ADDENDUM NO. 1

August 25, 2020

**RE: TOWN OF NORTHFIELD, VERMONT
UNION BROOK ROAD REHABILITATION PROJECT**

**FROM: DuBOIS & KING, INC.
6 Green Tree Drive
South Burlington, Vermont 05403
(802) 878-7661**

SHEET 7 OF 27

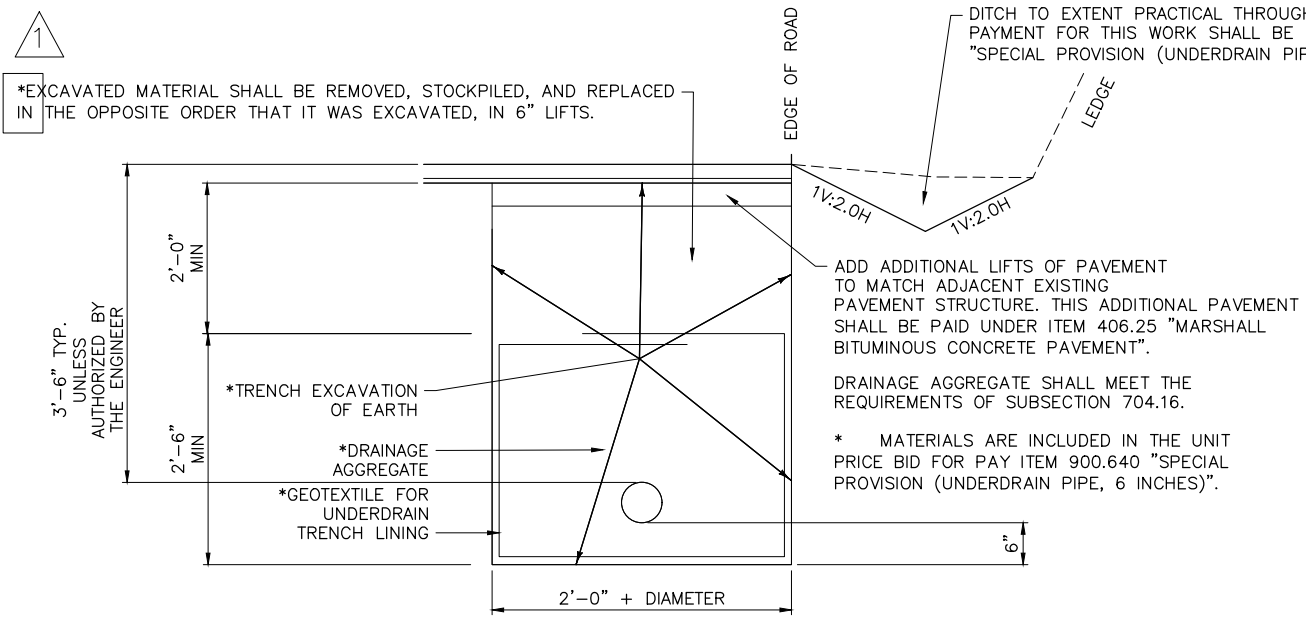
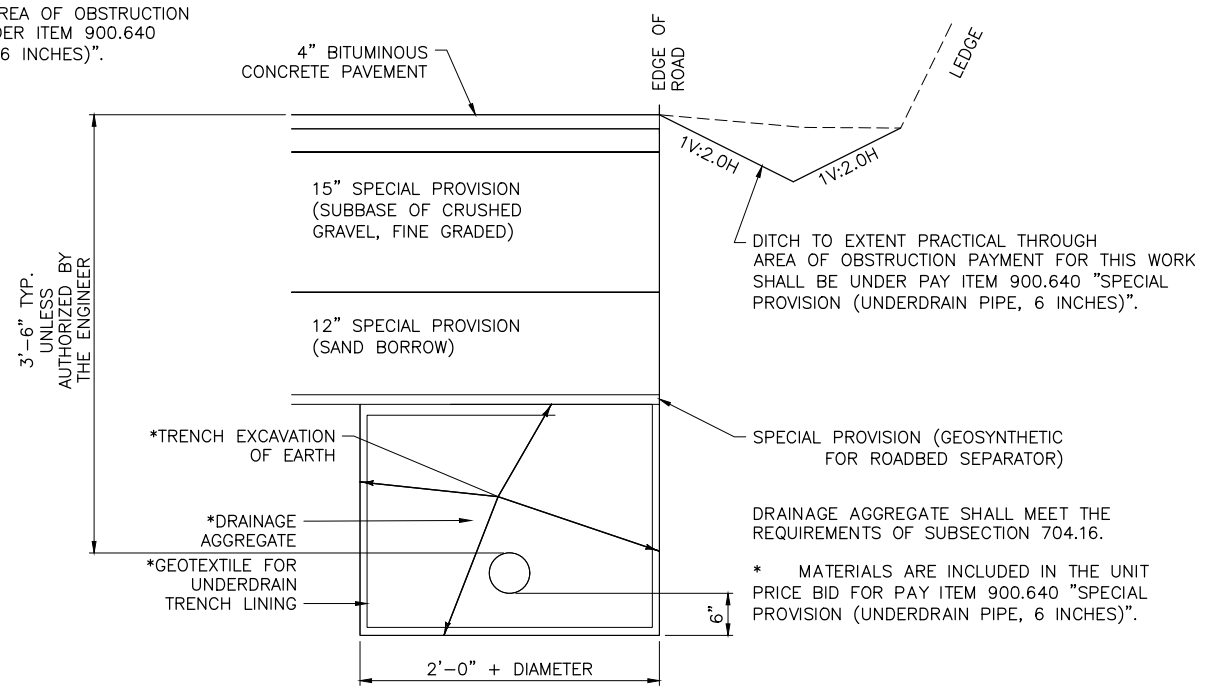
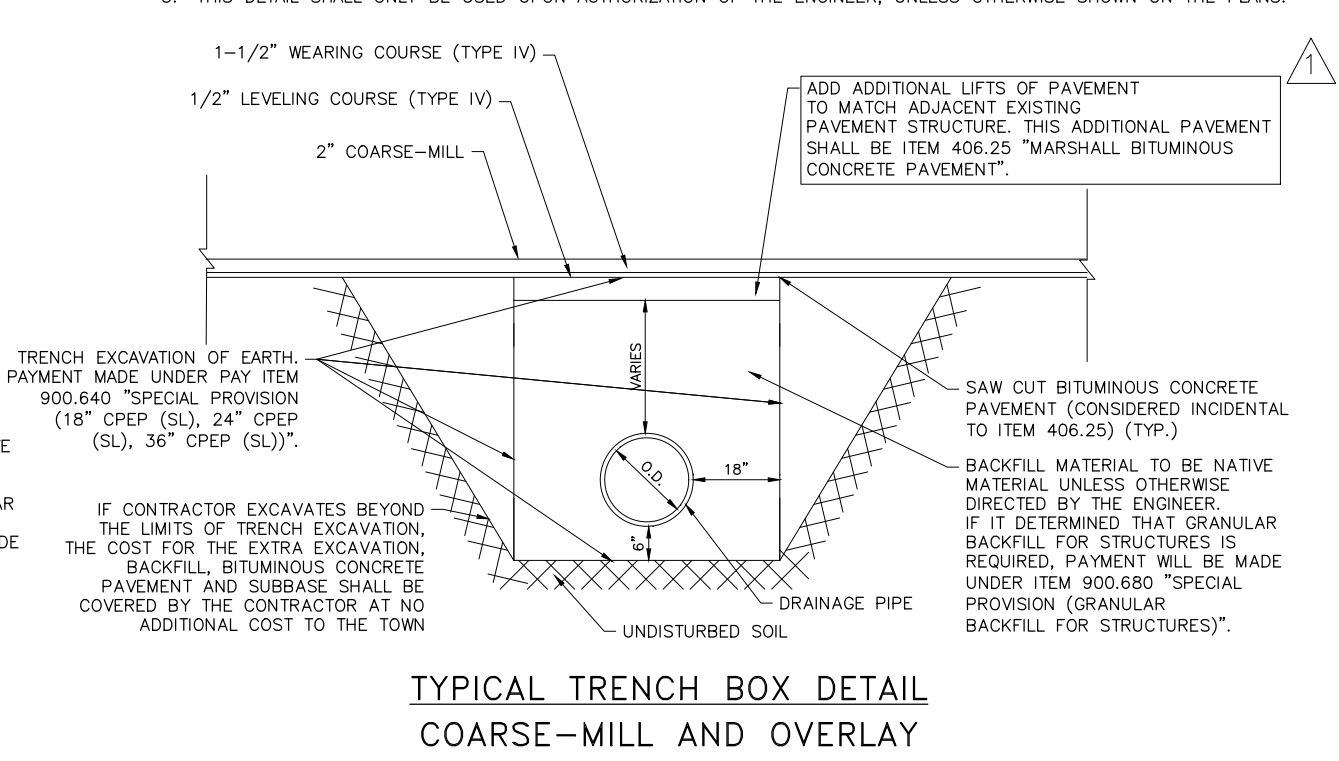
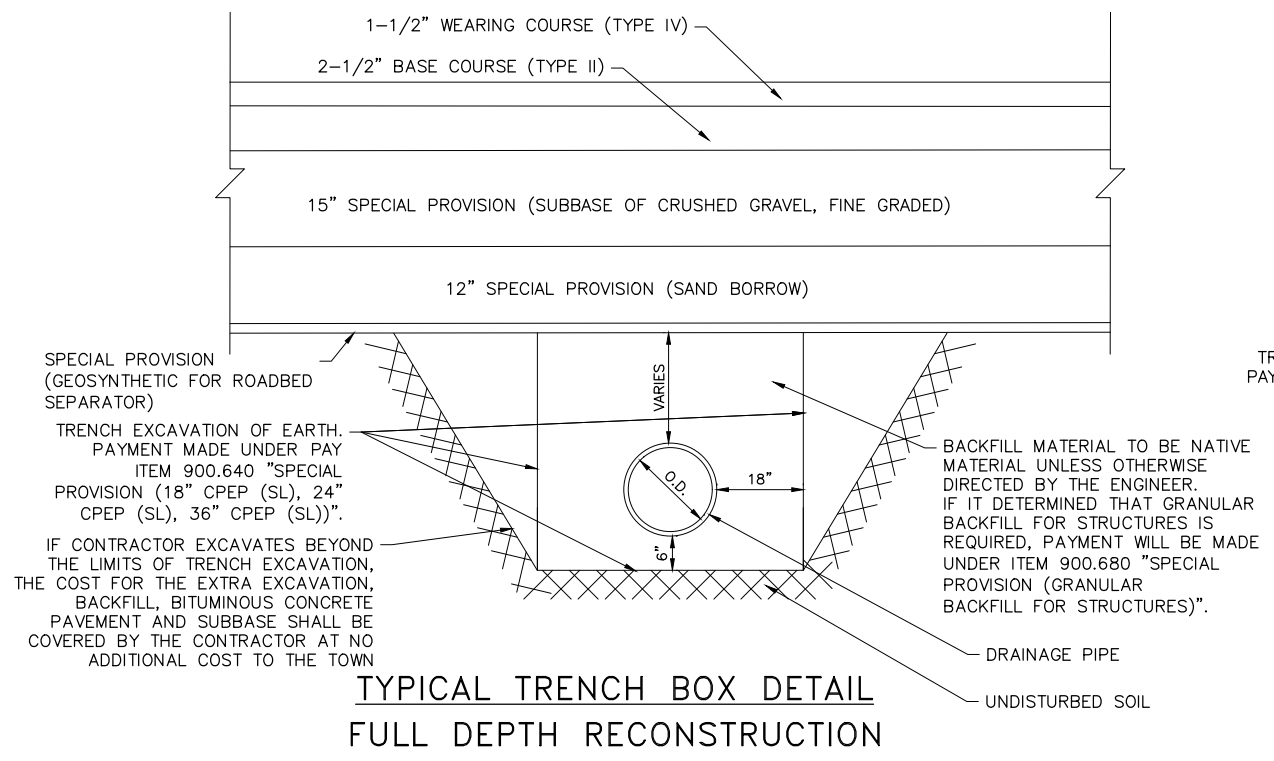
REVISED attached Sheet 4, 7 and 8 are included as **Attachment 4** of this Addendum and replace the corresponding original sheet in the Plans.

DETAIL SHEET 4

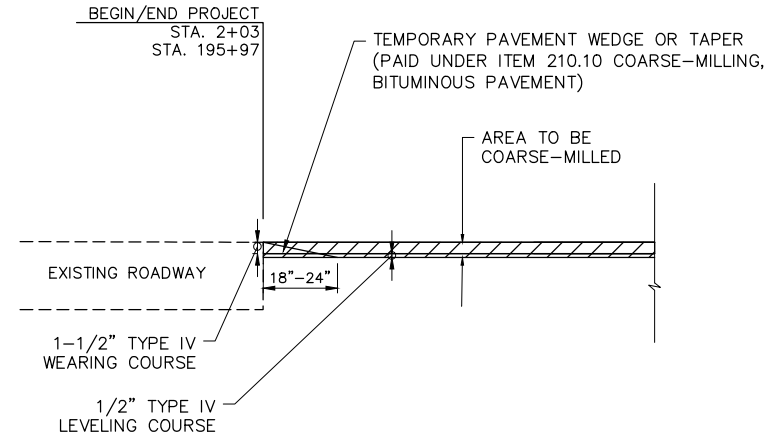
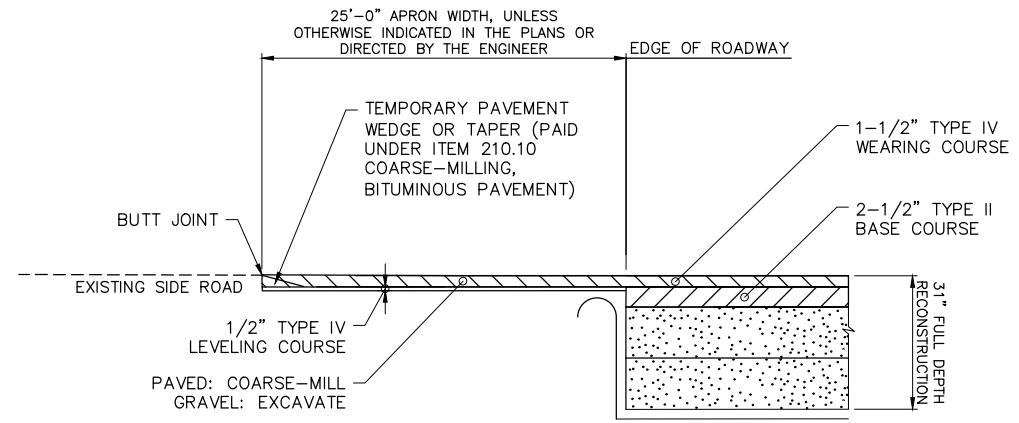
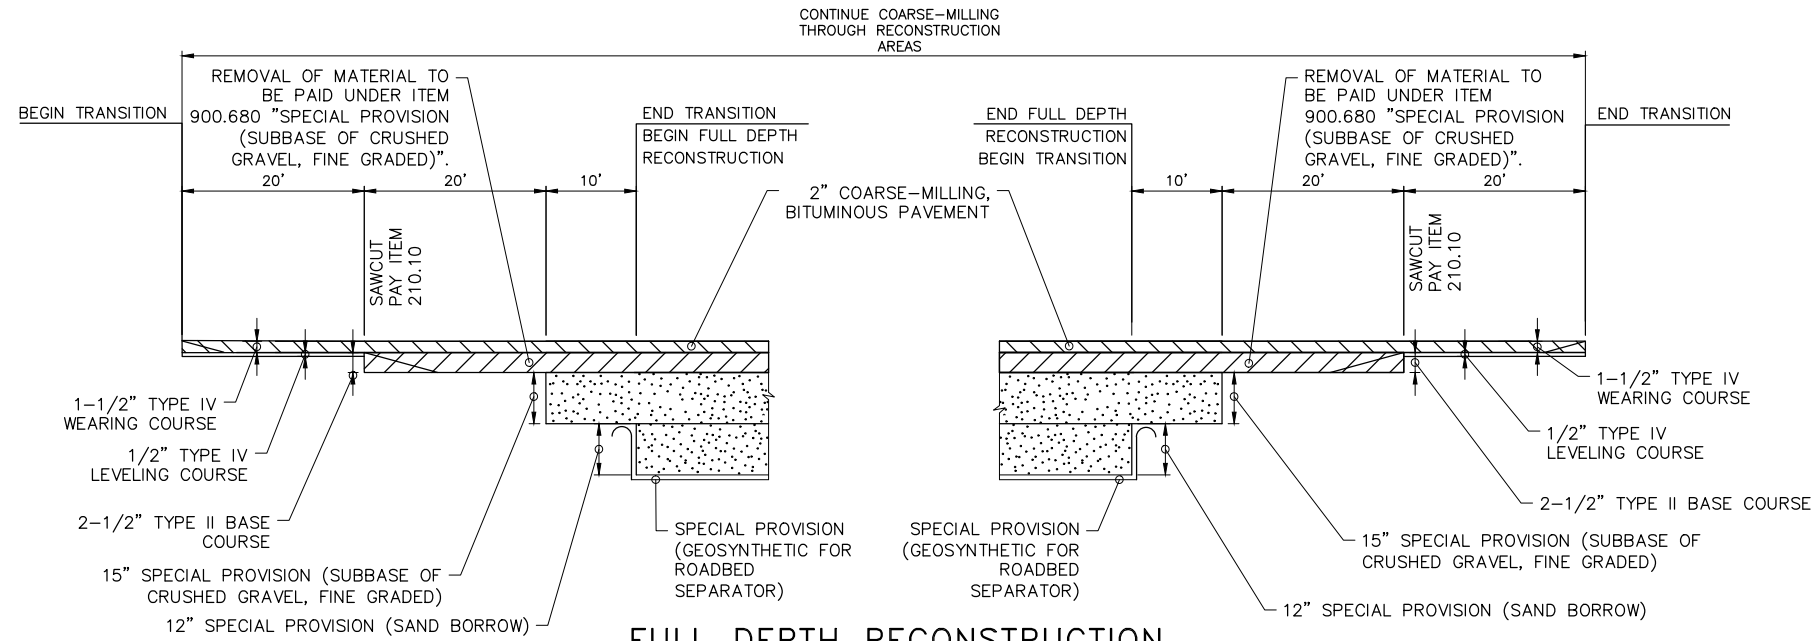
Question 8: Is there a full depth reconstruction from Sta. 102+00-106+50? Because this is shown on plan sheet #3, but plan sheet #4 shows a straight cold plane 2", shim and overlay from Sta. 83+50-166+00, and then the transition diagrams on sheet #8 do not show any transitions in the 102+00-106+50 area.

Question 9: It appears based on the bid quantity for cold planing and transition details on Sheet #8, that your intent is to pay for cold planning the entire 19,394 LF of the project. Can you confirm this?

Answer 8: Contract Plans have been updated (See **Attachment 4**).

Answer 9: Correct, but the contractor has the option to excavate through the full

depth reconstruction areas (See Note 1 on Detail Sheet 4 in the Contract Plans).
